ENGINE - DIFFUSER AND COMBUSTOR GROUP - SHOTPEEN THE NO.4 BEARING SUPPORT - CATEGORY  
CODE 5 - MOD.ENG-72-0040

V2500-ENG-72-0040

Location of No.4 Bearing Support Assembly  
Fig.1

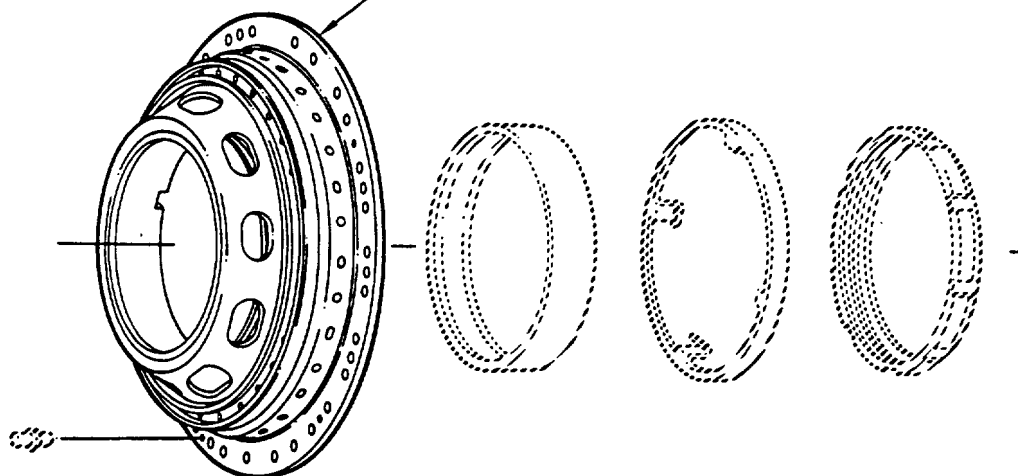
REMOVE THE PN 2A0846 No.4 BEARING  
SUPPORT ASSEMBLY (1 Off) DO A  
MODIFICATION, IDENTIFY, AND INSTALL  
AS PN 2A2038 No.4 BEARING SUPPORT  
ASSEMBLY (1 Off)

Modification of No.4 Bearing Support Assembly  
Fig.2

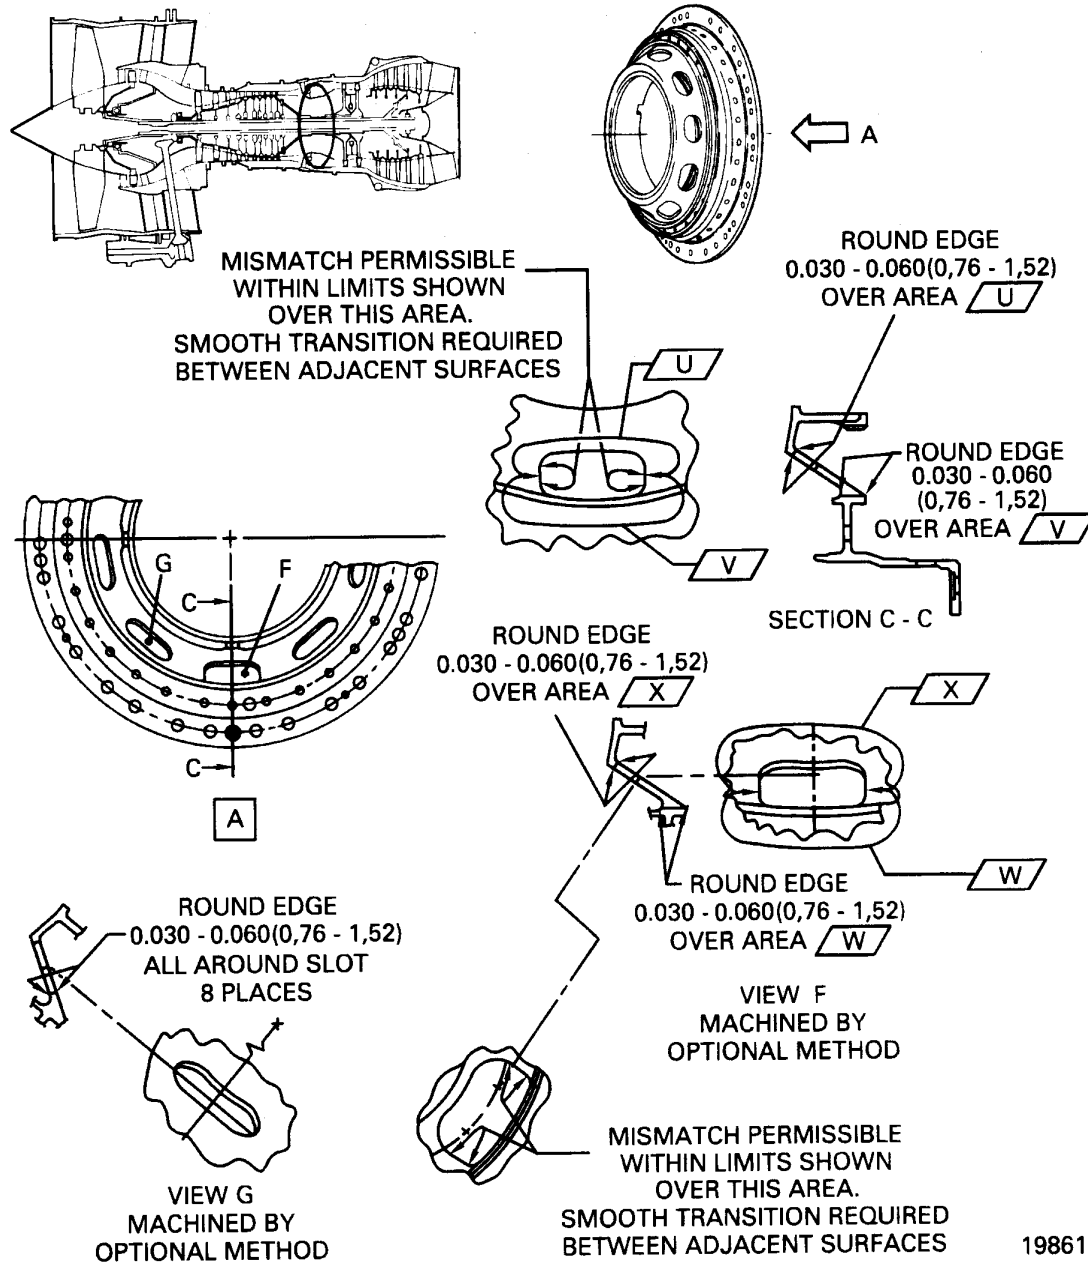
Procedure	Supplementary Information	
(a) Round the edges of all the slots in the No.4 Bearing Assembly	Refer to Figures 1 and 2 requirements	
(b) Shotpeen the No.4 Bearing Support Assembly to an intensity of 6A using SAE 170 maximum cast steel shot (Hardness 45-55 HRC or equivalent) by TASK 70-38-13-380-501 (AMS 2430)	Refer to Figures 1 and 2 requirements. Refer to the approved procedure in Reference (3) Chapter/Section 70-38-13 Surface Treating	
(c) Mark the new part number adjacent to the old part number. Use the vibration peen method	Existing	New Number
	2A0846	2A2038
